# Service Bulletin

## 2014 NC700X/XD Combination Meter Replacement PRODUCT UPDATE CAMPAIGN

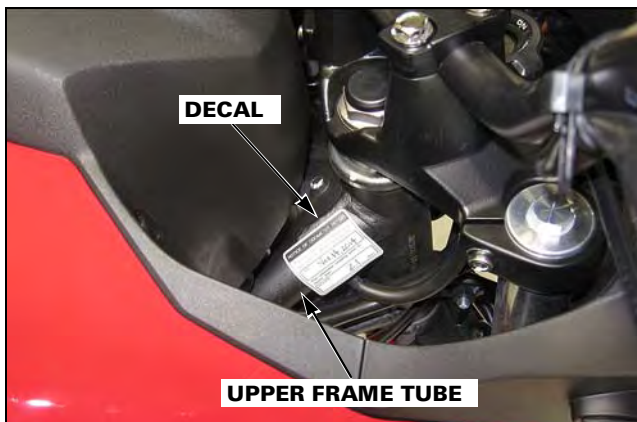
3. Peel off the blue adhesive backing from the decal and then apply the decal to the upper frame tube at the position shown.

**NOTE:** If the original odometer indicates mileage, by law the decal must be applied. The decal is a one-use type and will self destruct if you try to remove it after initial application. Be sure to clean the frame surface with isopropyl alcohol and then apply the decal correctly the first time.

**IDENTIFICATION**

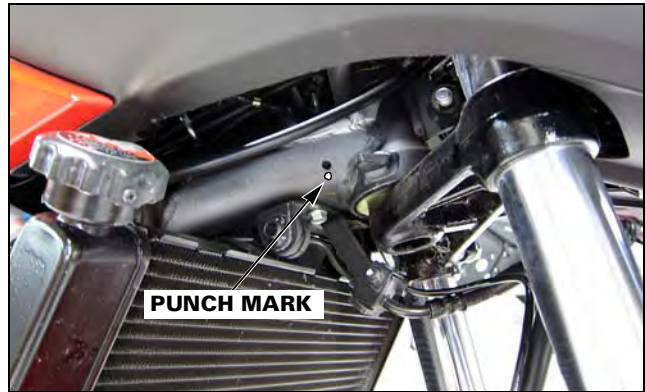
When you have completed the update, place a punch mark on the right side of the frame, just below the drain hole as shown.
